Subject: Ref 2016/3132/P - erection of new 5 storey building, 145-147 Camden Road,

FAO – Elaine Quigley Ref – 2016/3132/P

Proposal – Erection of new 5 storey building on land to east of existing motor vehicle maintenance and repair centre for office use

Location - 145-147 Camden Road, London, NW1 9HA

Attachments: Portal site map.pdf

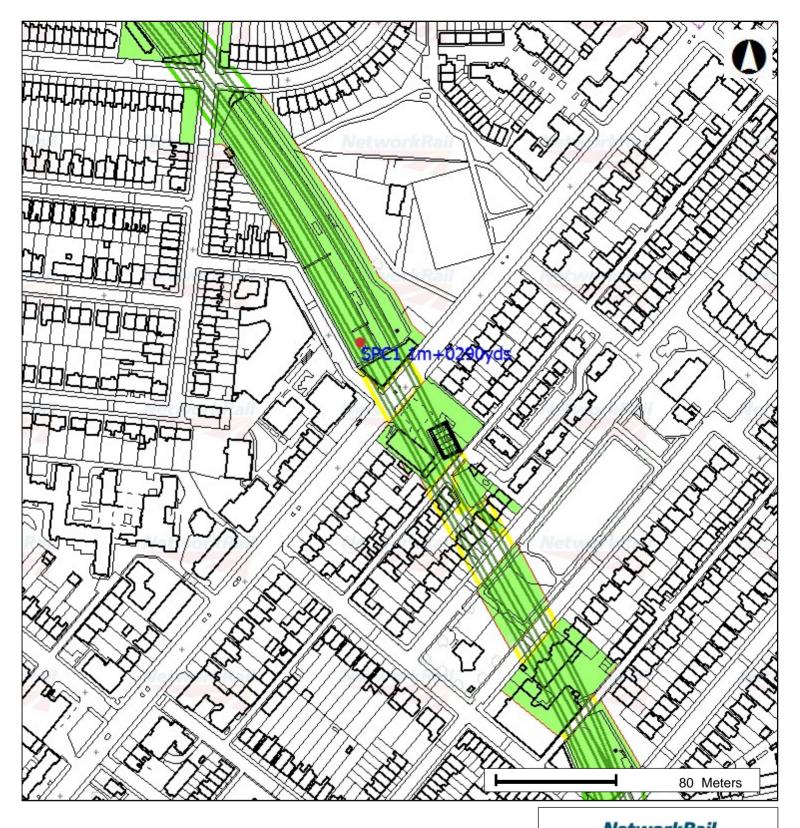
With reference to the protection of the railway, Network Rail has several concerns in relation to these proposals and cannot support the proposals in the current format. This is because the development as proposed appears to be partly located on an area of land still in the ownership of Network Rail. The attached plan shows the land in Network Rails ownership (shaded green).

It is therefore appropriate that the applicant re-submit the redline plan showing the correct boundary or contact Network Rail at landinformation@networkrail.co.uk to discuss the boundary issue and reach agreement.
